STATEMENT OF EVIDENCE

Paddy Baxter

Orchard Road Holdings Ltd (ORHL)

Plan Change 46 Ballantyne Road Industrial and Residential Extension

+ BALLANTYNE RIDGE - SETBACK AND BUFFER PLANTING ELEVATIONS

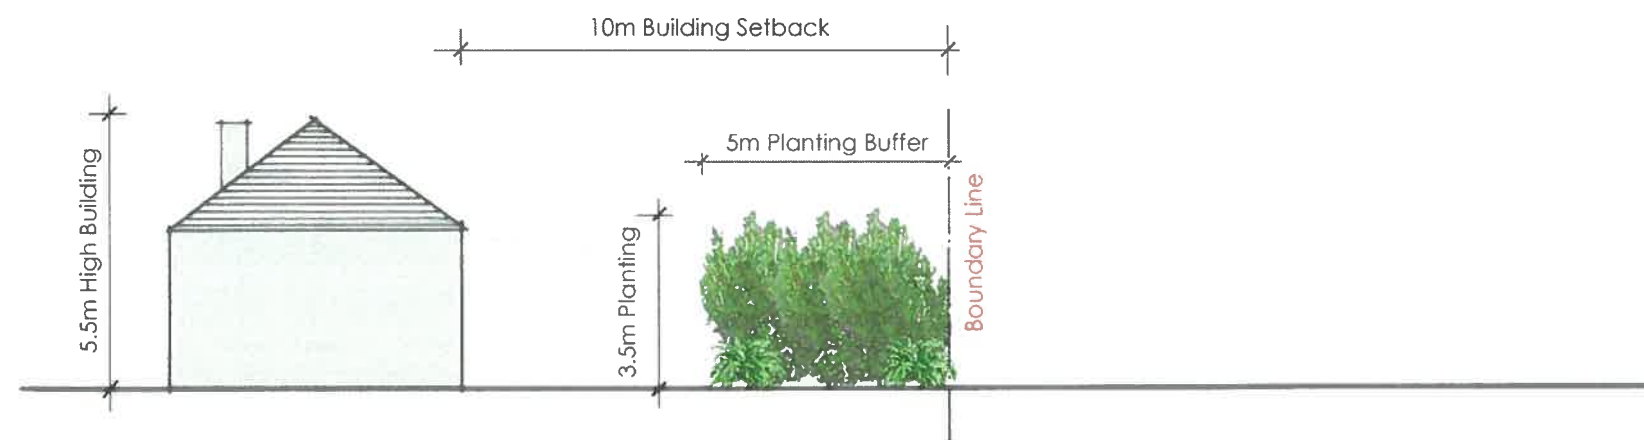
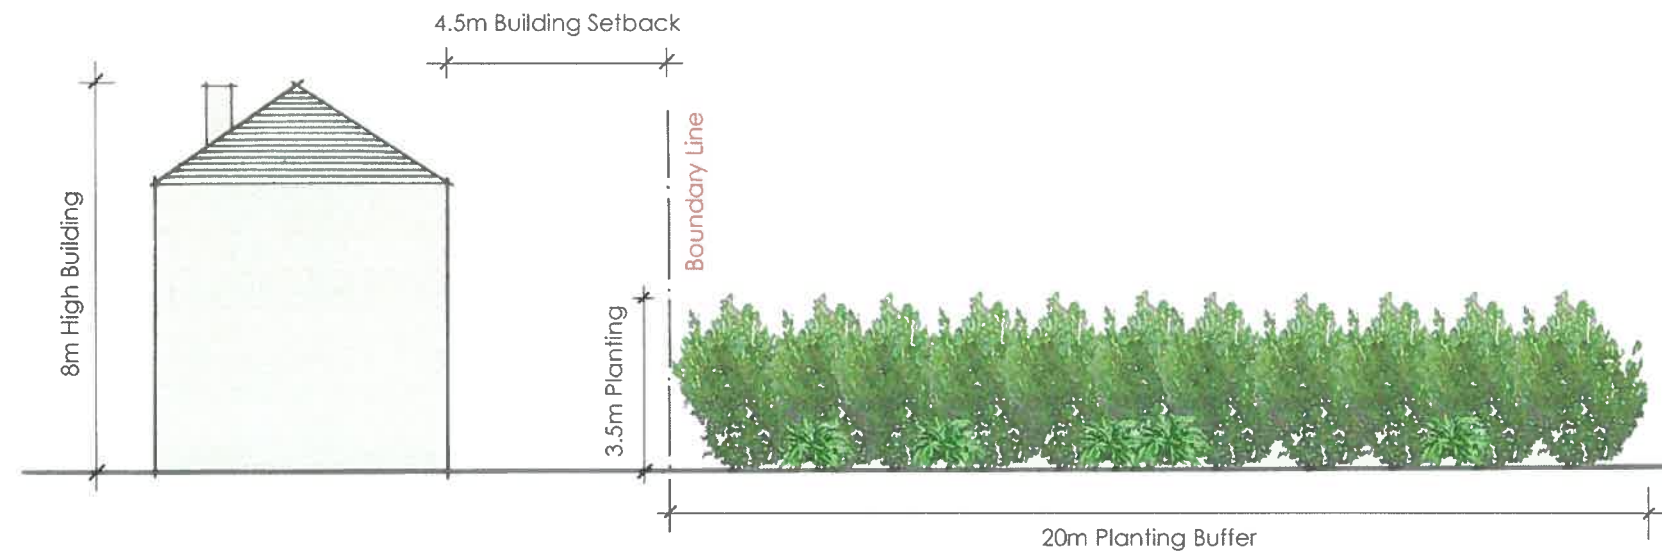
9. Taking the above into consideration I believe that there are more appropriate forms of mitigation that would work. This could utilise a combination of planting and design controls, with the end effect being glimpses of single level buildings set back from strong planting. I have attached a drawing (*refer BDG 1786 – SK04 Setback and Buffer Planting elevation*).

10. This drawing shows 2 scenarios: Both options show planting on level land to a height of approximately 3.4-4 metres. I have also shown 2 building heights: One being an 8 metres building and the other a 5.5 metre building.

11. My preferred **recommendation** would be the following:
- That a 10 metre setback is established within lots that adjoin the SW and SE boundaries of the proposed Low Density residential area.

- Within that 10 metre setback 5 metres of planting adjacent to the boundary shall be undertaken by the individual landowner or developer, to a density and type to be specified in an agreed set of controls. The planting should select evergreen shrub species of a mature height of approximately 3-4 metres. Indigenous plantings would be most suitable

- That dwellings within the specified lots, where the setback is required, would be subject to design controls that require recessive colour controls on walls and roofs, above and beyond those on the rest of the Low Density Zone and should be no greater than 5.5 metres in height.
